SECTION: 204-05

Service Action: Air Suspension Compressor Blocked

Range Rover Sport (LW)

Range Rover (LG)

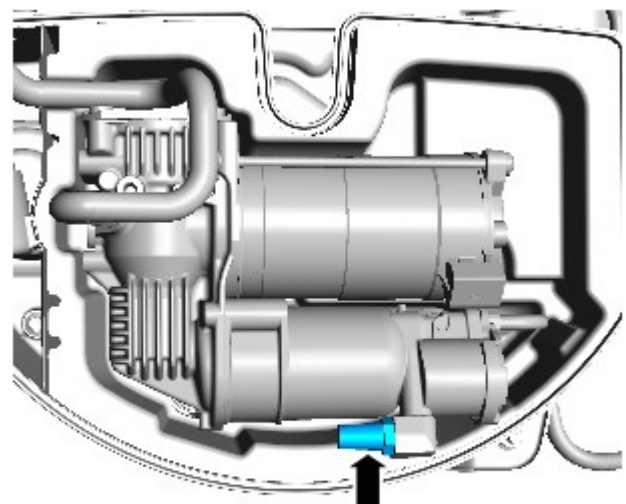
15. Check for white powder at the suspension air supply unit silencer.

- If white powder is present at the silencer **(A)** , replace the suspension air supply unit (see TOPIx Workshop Manual, section 204-05: Vehicle Dynamic Suspension).
- If no white powder is present at the silencer **(B)** , continue to the Step 16.

E193912

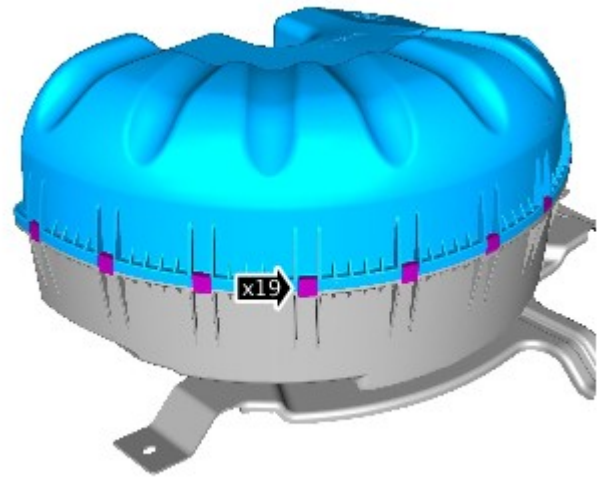
16.  **CAUTION:** Make sure to support the plastic casing when unscrewing the air suspension compressor silencer, there is a possibility of damaging the suspension air supply unit silencer if not careful.

Replace the suspension air supply unit silencer.

1. Remove the suspension air supply unit silencer from the suspension air supply unit.
2. Install the suspension air supply unit silencer into the suspension air supply unit.

- Torque: 2.5Nm
